SYNGENE INTERNATIONAL LTD, VELANKANI TECH PARK, ACCESSIBILITY AUDIT REPORT

PREPARED BY SVADHIN SOLUTIONS

GROUND FLOOR, SYNGENE INTERNATIONAL, VTPL – ACCESSIBILITY OVERVIEW

CONFERENCE ROOMS

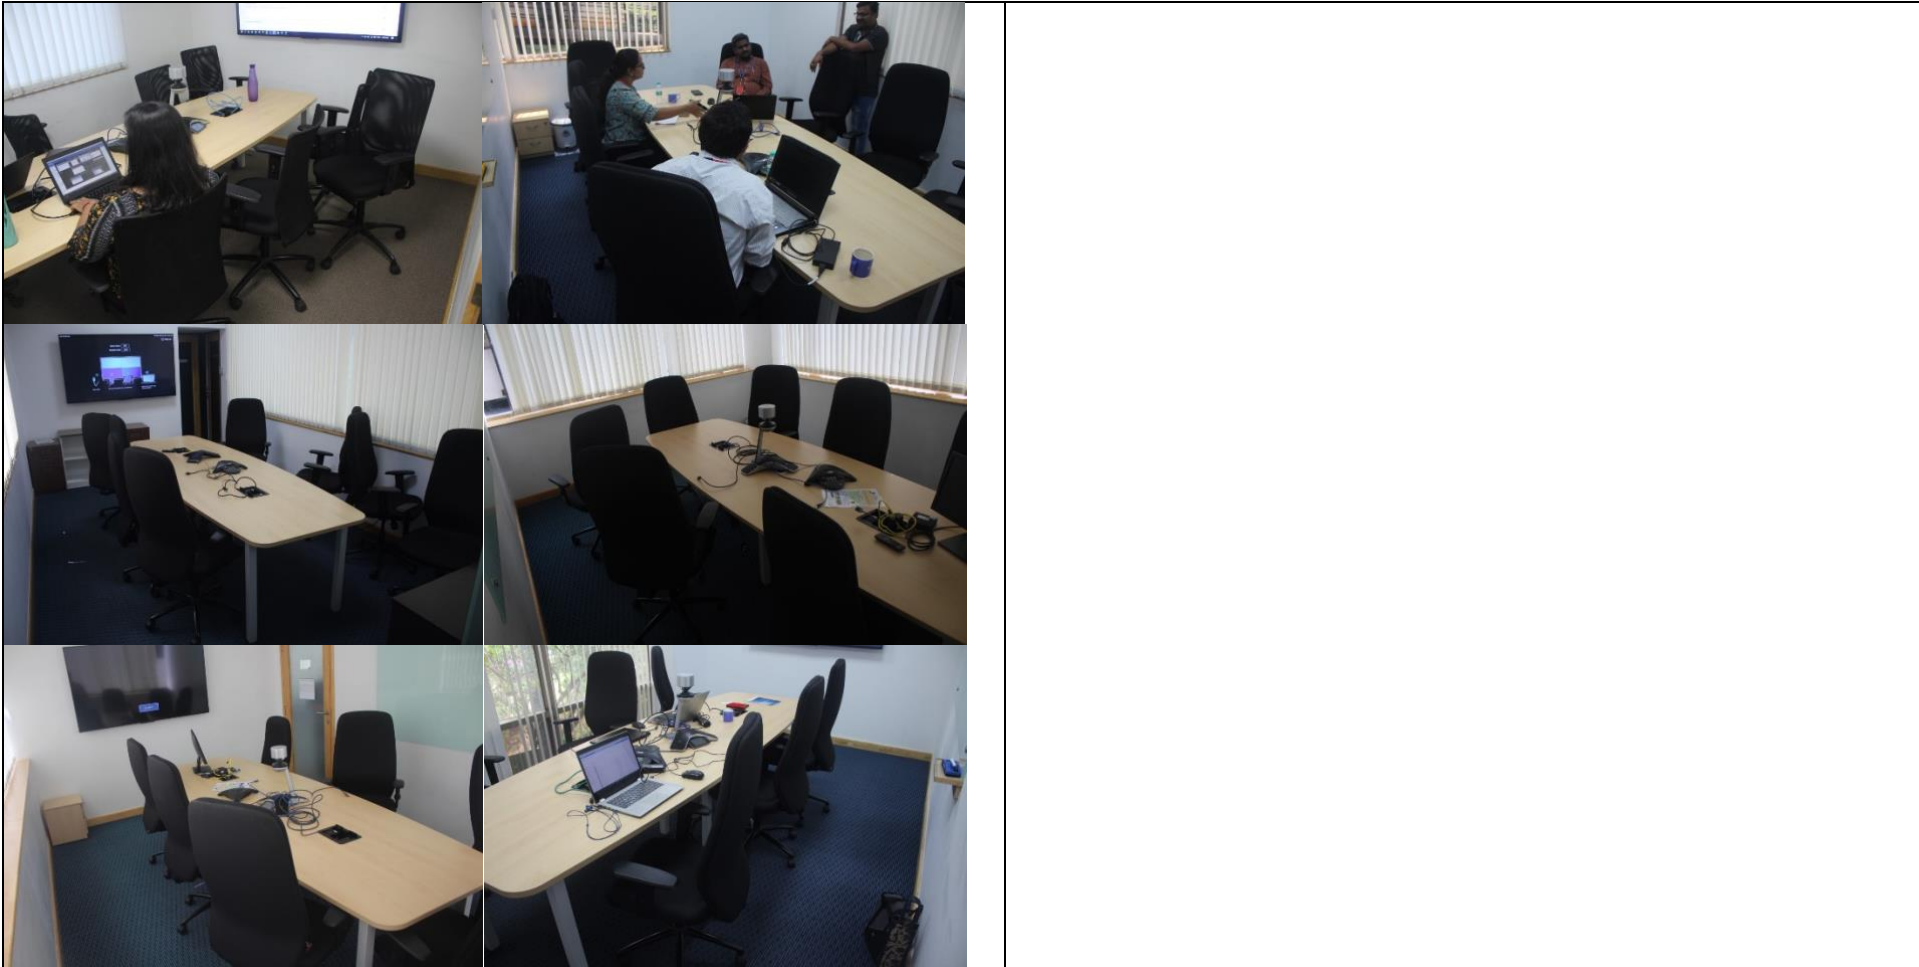
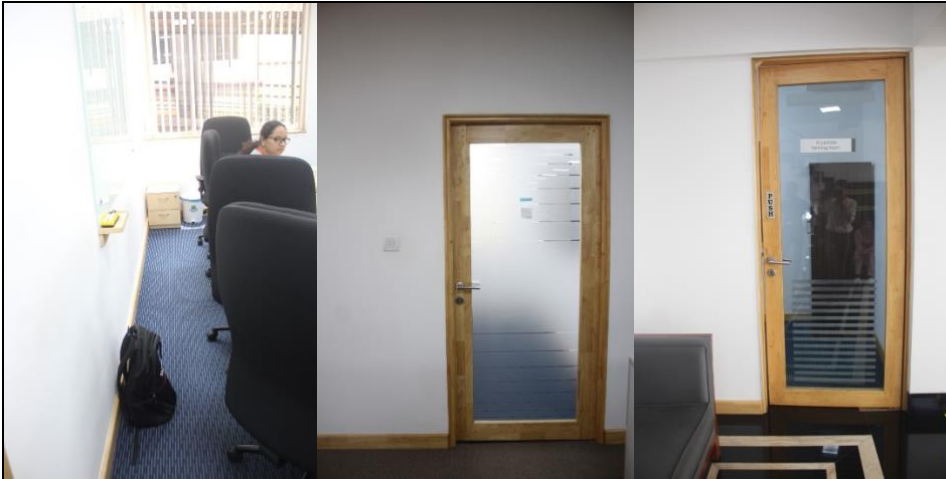
- All the conference rooms' entry doors have high door tension, non-compliant door widths (except for one conference room in second

<p>floor), and handles placed at non-compliant heights except for the conference rooms with long vertical handles that are placed at inaccessible heights making these entries non-compliant and inaccessible for PwDs</p>
➤	<p>All the conference rooms with signage have them placed at non-compliant heights with no provisions for braille and tactile and the rest don't have signage at all making these entries non-compliant and inaccessible</p>
➤	<p>The conference room on first floor with toilet has non-compliant and inaccessible pull side door clearance making this entry non-compliant and inaccessible to access for certain PwDs</p>
➤	<p>Most of the conference rooms have non-compliant and/or inaccessible chair clearances as marked in the floor plans making these rooms either completely and/or that part of the conference room inaccessible and non-compliant for PwDs</p>
➤	<p>None of the conference rooms have loop induction units as per compliance to support people with hearing impairment</p>

➤	<p>All the conference rooms have whiteboards placed at heights that reduces the optimal usage area for certain PwDs</p>
➤	<p>Some of the conference rooms have marker holders that may act as projection and be unsafe for PwDs</p>
➤	<p>The conference room in the second floor with the toilet inside has cable cubbies placed at inaccessible depths making them inaccessible for certain PwDs to access and use</p>
➤	<p>The light switches in all conference rooms are placed at non-compliant heights with no colour contrast against the background walls making them non-compliant</p>

MEETING ROOMS

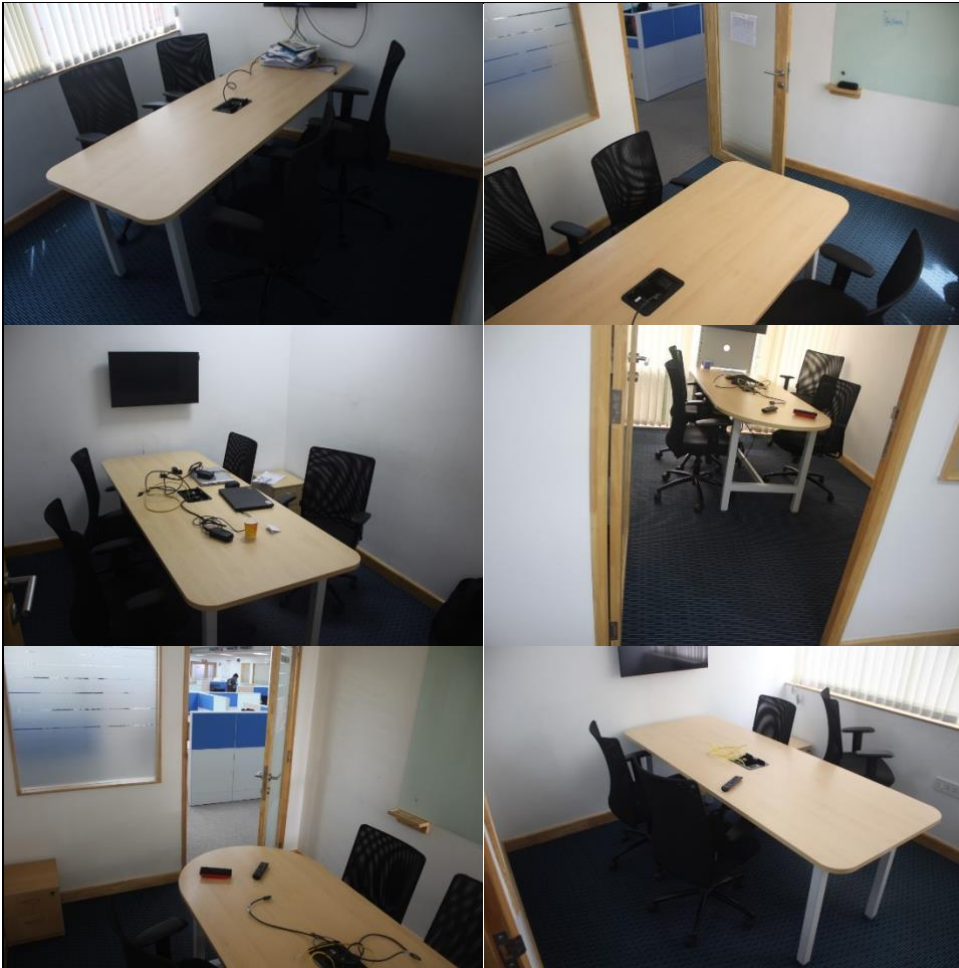
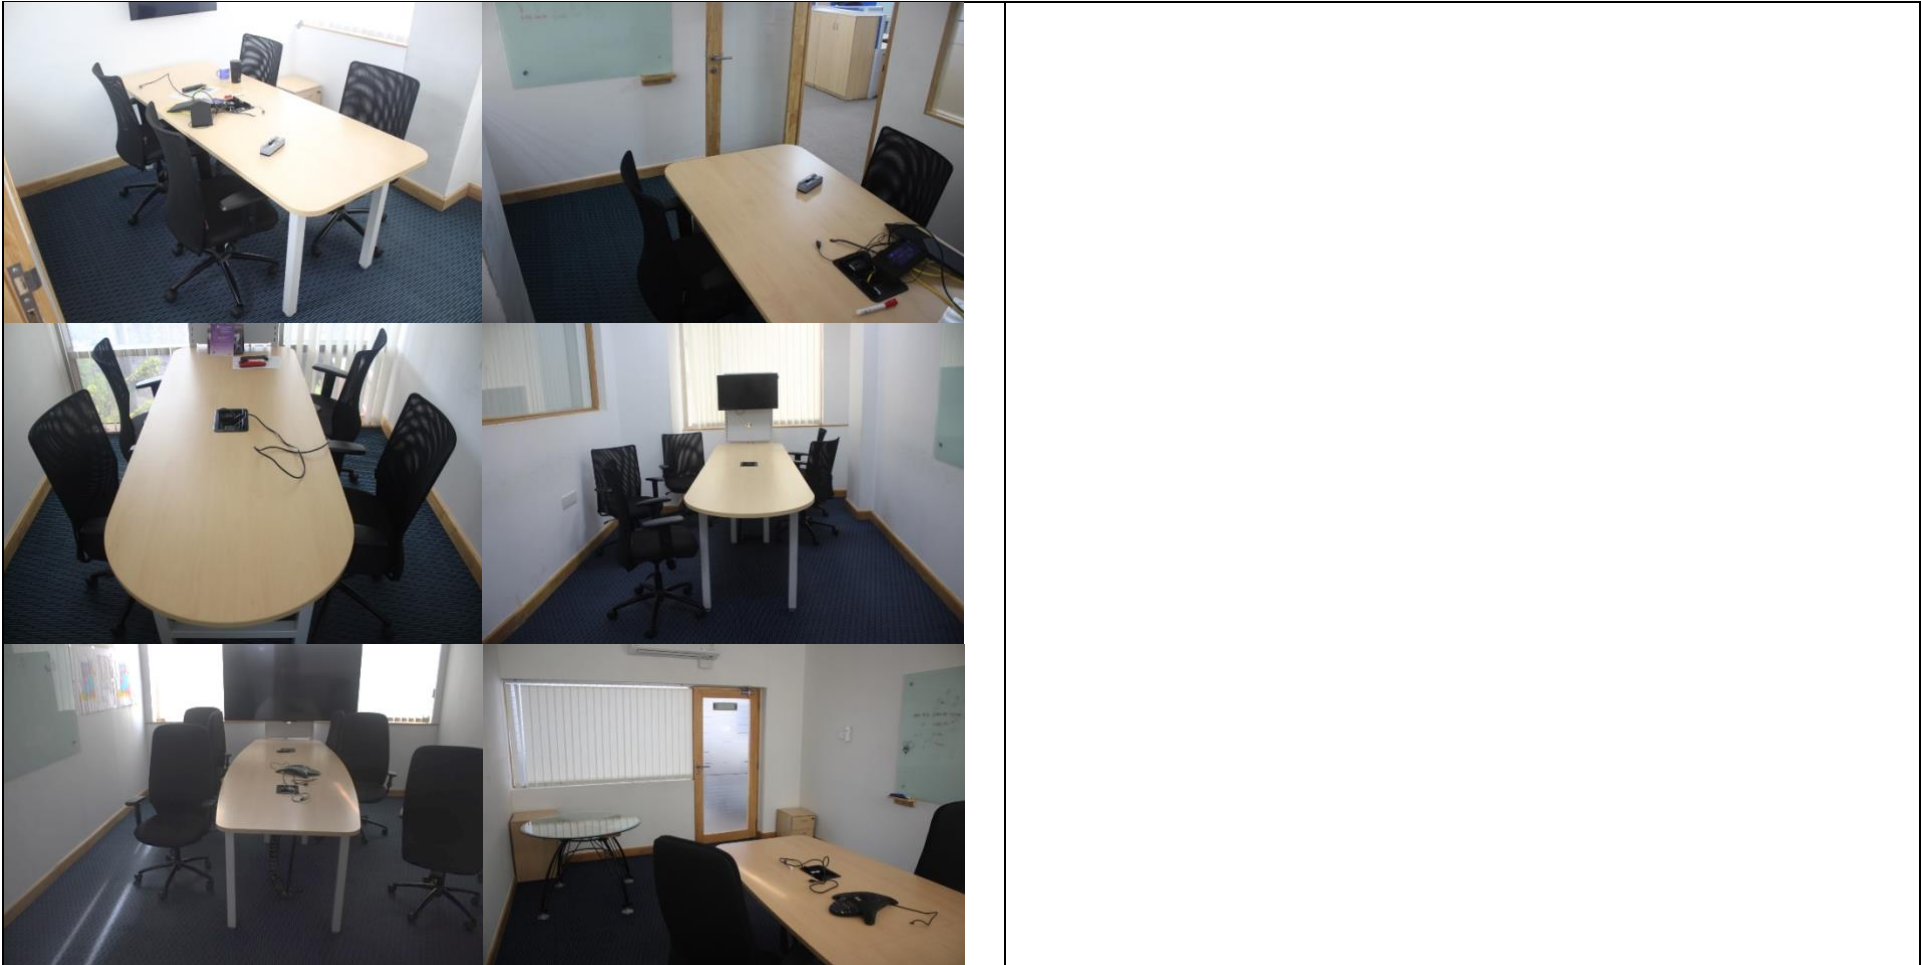
- All the meeting room entry doors have high door tension (except for three meeting rooms in the second floor), non-compliant door widths (except for one of the meeting rooms on first floor and three of the meeting rooms on second floor) and handles placed at non-compliant heights except for one of the meeting rooms with vertical long handles which is placed at inaccessible height making these entries non-compliant and inaccessible for PwDs
- All the meeting room entry doors have signage placed at non-compliant to inaccessible heights except for two that are at accessible heights and two that have no signage in place at all and none of the signage in place has provisions for braille and tactile making these entries non-compliant and inaccessible for certain PwDs
- Few of the meeting rooms have inaccessible pull and push side door clearances making these entries inaccessible for PwDs

- Almost all the visited meeting rooms have either non-compliant and/or inaccessible chair clearances as marked in the floor plan making these points congested and hard to use for PwDs

- Meeting rooms with a lot of non-compliant and/or inaccessible chair clearances will be too congested and therefore completely inaccessible for certain PwDs

- Whiteboards in all of the meeting rooms are placed at heights that reduces the optimal usage area for certain PwDs
- All the meeting rooms have light switches placed at non-compliant heights with no colour contrast against the background wall making them non-compliant

- A lot of the meeting rooms have marker holders that may act as projection and be unsafe for PwDs as the rooms itself are congested with non-compliant and/or chair clearances especially with the placement point of the marker holders

PANTRIES

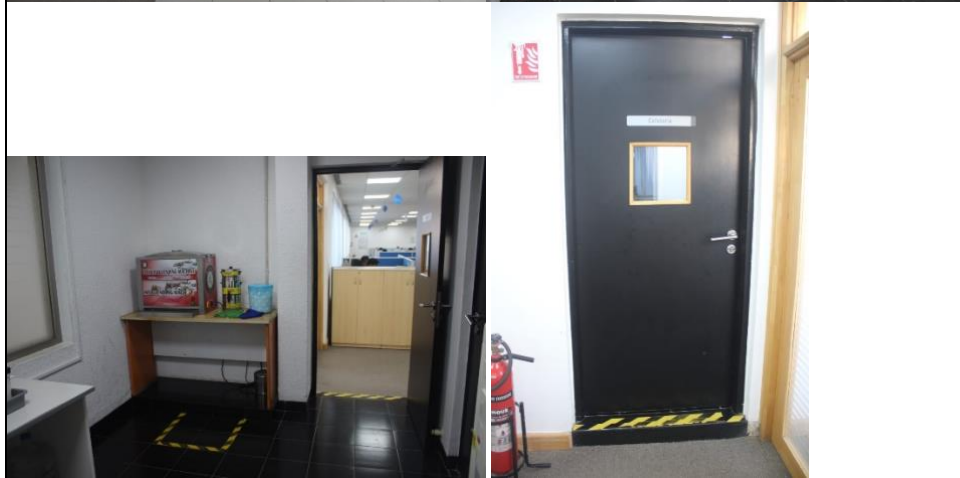
- The third floor pantry entry door has high door tension, non-compliant door width, inaccessible pull side door clearance, handles placed at non-compliant and inaccessible heights, inaccessible vision panel, ledge at the entry door and signage placed at non-compliant heights with no provisions for braille and tactile making this entry non-compliant and inaccessible

- All the pantries have hand sinks that are counter-mount and are inaccessible for wheelchair users as there is no knee clearance under the sink and at heights that makes them hard to use for people with dwarfism

- The tissue paper dispensers and the soap dispensers are placed at inaccessible heights and/or points making them inaccessible and non-compliant for certain PwDs

VENDING MACHINE

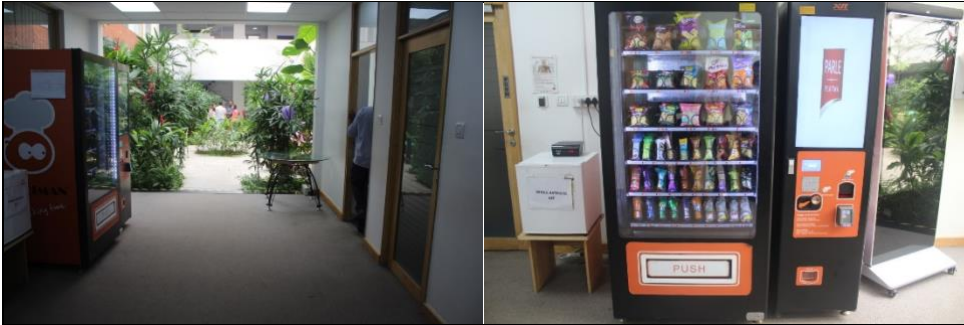
- The pickup point of the vending machine is at inaccessible height and the control panel is at a non-compliant height

- The vending machine control panel does not have braille/tactile labelling method and/or audio provisions for identification of items in the vending machine

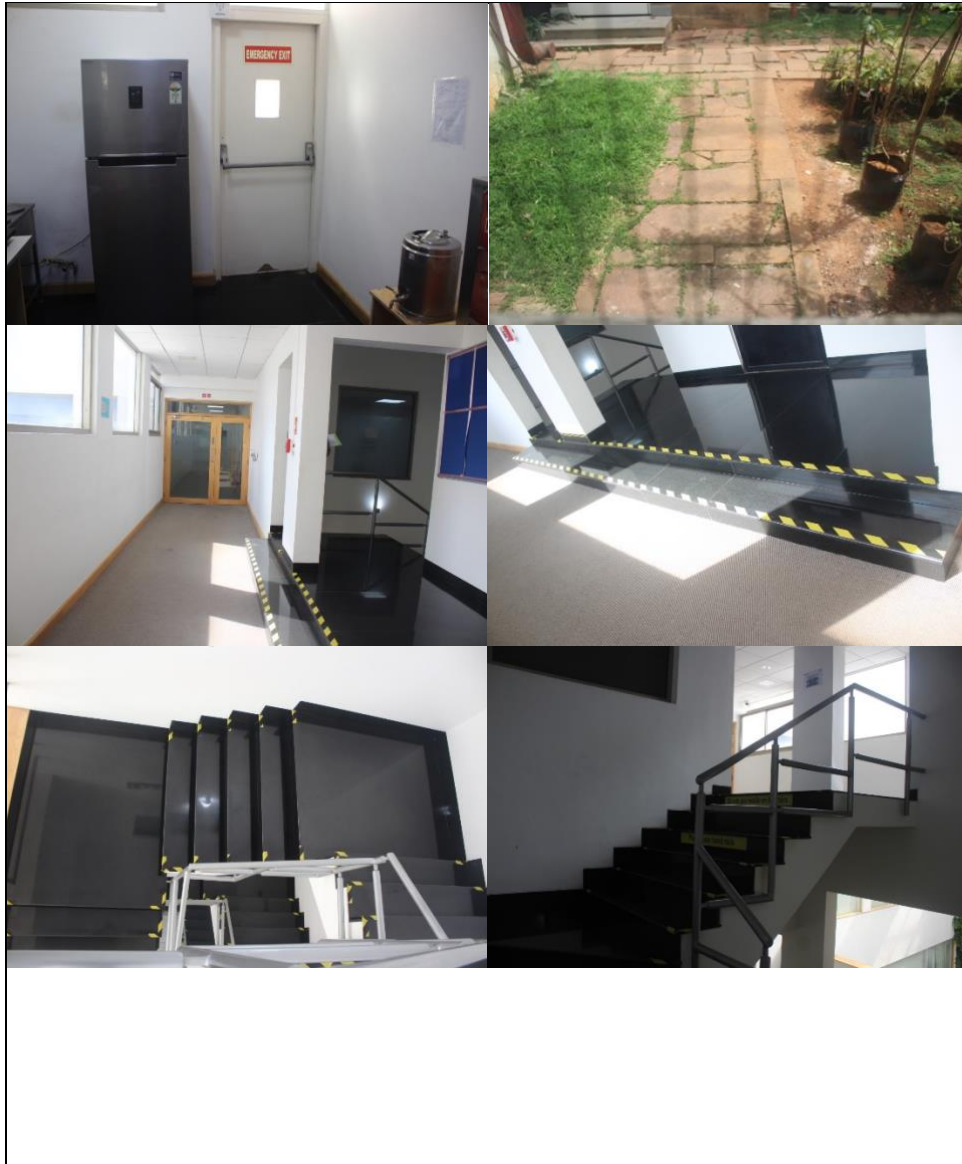
- There are no emergency evacuation protocols for PwDs in place

- There are no PwD specific rescue assistance areas in the floor with the required aid and structural compliance
- The emergency call button in the lift is placed at an inaccessible height with no provisions for braille and tactile making them non-compliant and inaccessible for certain PwDs during an emergency

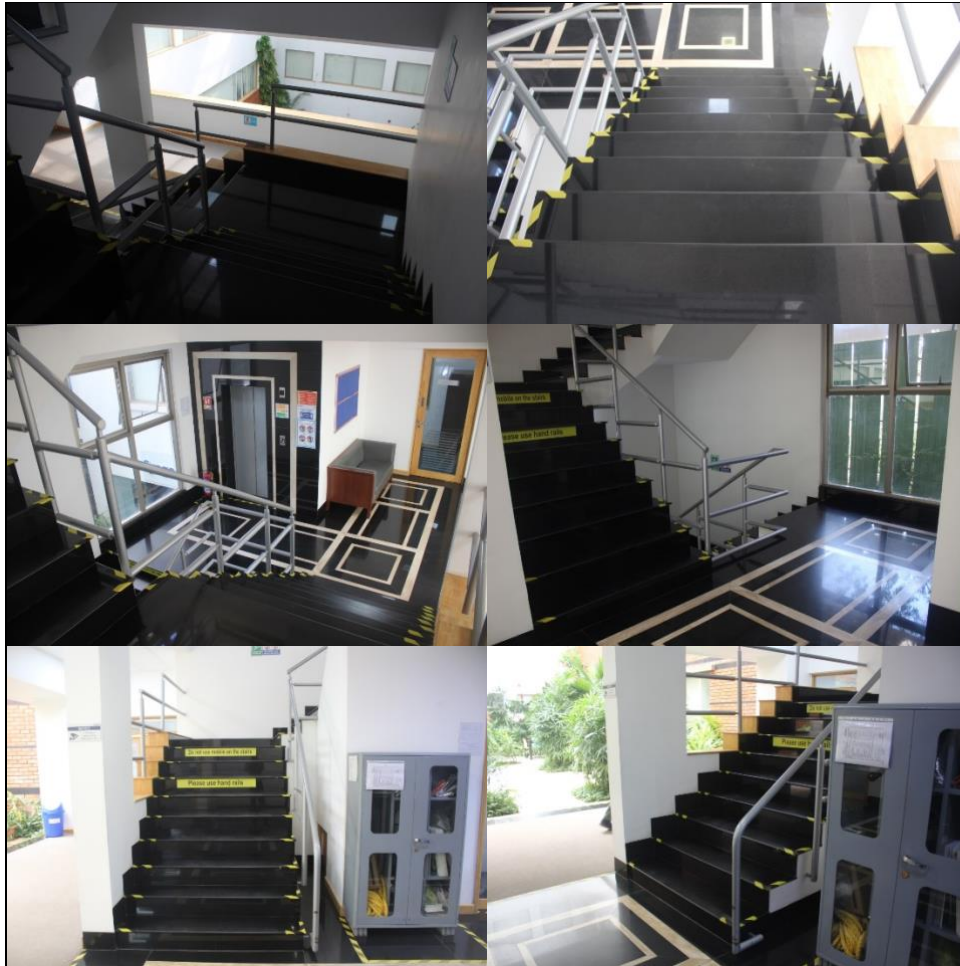
- The ground floor emergency exit door has a step at the exit point without any clear landing area after the door which can be unsafe for certain PwDs especially during an emergency evacuation

- The path leading away from the building after the ground floor emergency exit door has uneven surface making this exit route inaccessible and unsafe for PwDs
